4.2 10 CFR 61.41 – PROTECTION OF THE GENERAL POPULATION FROM RELEASES OF RADIOACTIVITY (UAC RULE R313-25-20)

Figure 5-10 – DEQ-calculated fraction of GWPL for various radionuclides as a function of time based on inventory of clean DU waste only (fission products absent) at the 90-foot well (unconfined aquifer)

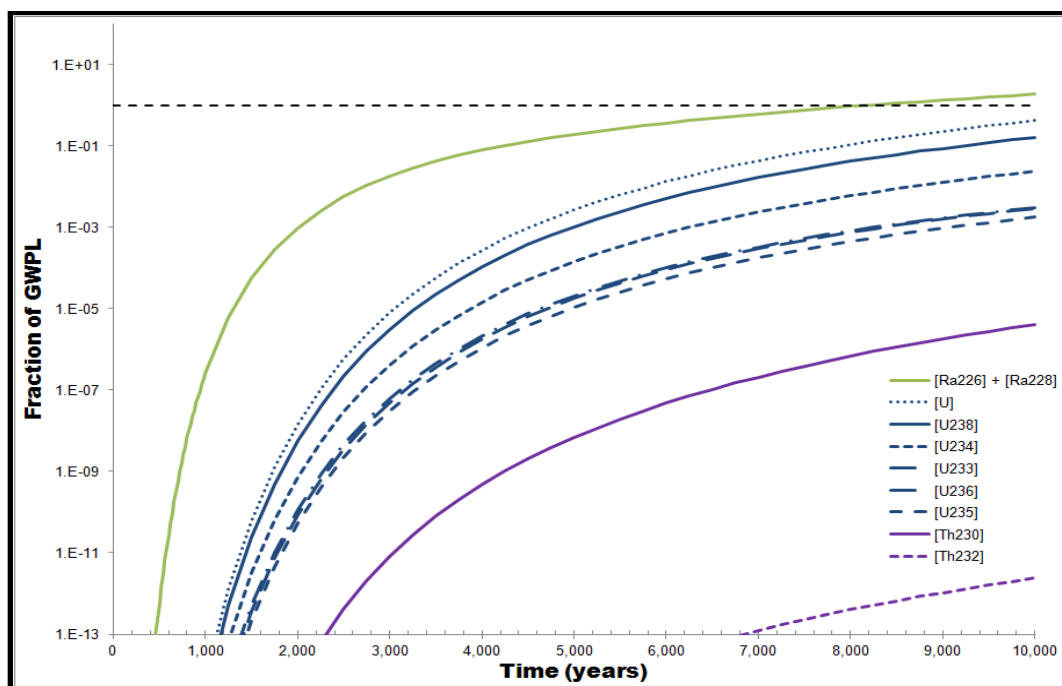
For the second case, DEQ assumed that only clean DU (no fission or activation products) was emplaced. The results are shown in Figure 5-10. At about 8,500 years, the Ra-226 + Ra-228 concentration exceeds the GWPL of 5 pCi/L, while at 10,000 years the Ra-226 + Ra-228 concentration is 21 pCi/L. Thus, the radium GWPL of 5 pCi/L in the upper, unconfined aquifer would be exceeded at the 90-foot buffer zone well, but not until long beyond the 500-year GWPL evaluation period. Based on the EnergySolutions Round 2 Response to Interrogatory CR R313-25-19-182/2: Groundwater Exposure Pathways (ES 2014a), the dilution factor [as calculated in EnergySolutions (2014e) using the Dupuit-Thiem equation] between the upper, unconfined aquifer and the lower, confined aquifer is 3.28E-03, which would result in radium

While the Ra-226 + 228 concentration will exceed the GWPL in the upper aquifer after about 8,000 years, the 500-year compliance point specified in Utah GWQ Permit No. UGW450005 is met, as discussed previously. In addition, the maximum ingestion dose within the first 10,000 years from Ra-226 is 2.32E-03 mrem/yr and from all radionuclides is 9.24E-02 mrem/yr. Clearly, these values are well below the exposure limit for members of the general public—4 mrem/yr TEDE from groundwater as specified in UAC R313-25-20.
